IFB SA 2409 Wellington Road Operations Center Expansion

**Addendum #3**

## **IFB SA 2409 Wellington Road Operations Center Expansion Addendum #3**

### **Questions and Responses**

LANDSCAPE NOTES & DETAILS  
 WELLINGTON ROAD OPERATIONS  
 CENTER EXPANSION  
 BREWSTERVILLE, VIRGINIA  
 PRINCE WILLIAM COUNTY, VIRGINIA

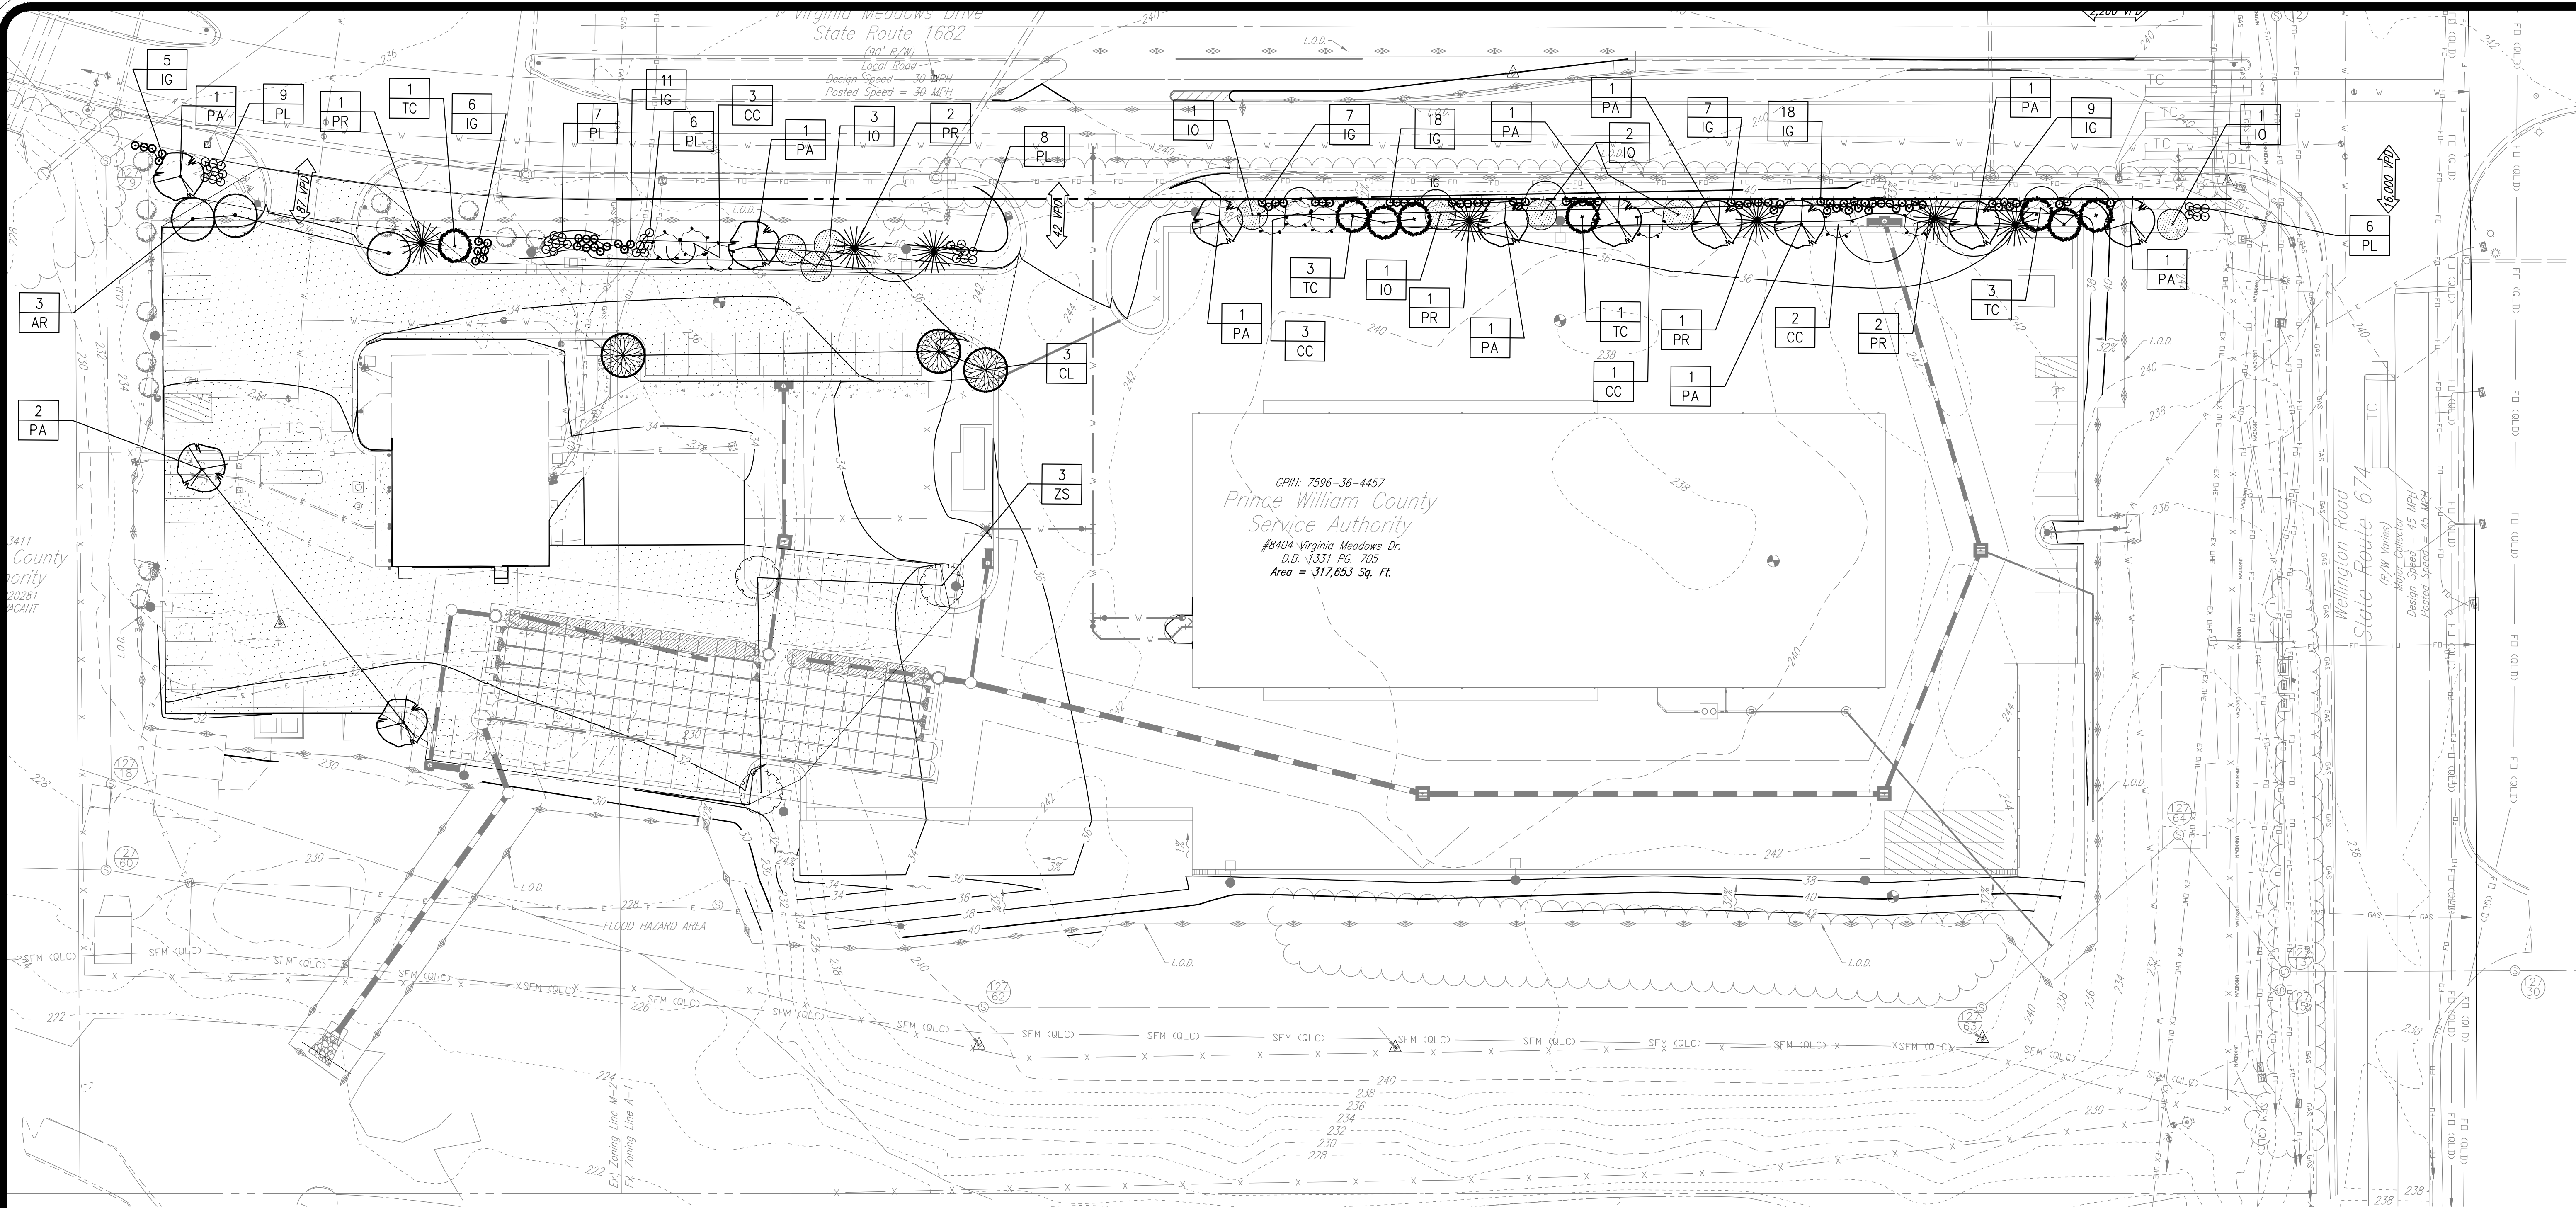
**65. Question:** Reference detail 5 on C.11. The note for the tree protection fence says to see detail 3. I didn't see a detail 3 on the plans for the tree protection fencing. Please provide a detail for the tree protection fencing.

**Response:** A detail for tree protection fencing has been added to sheet C.17.
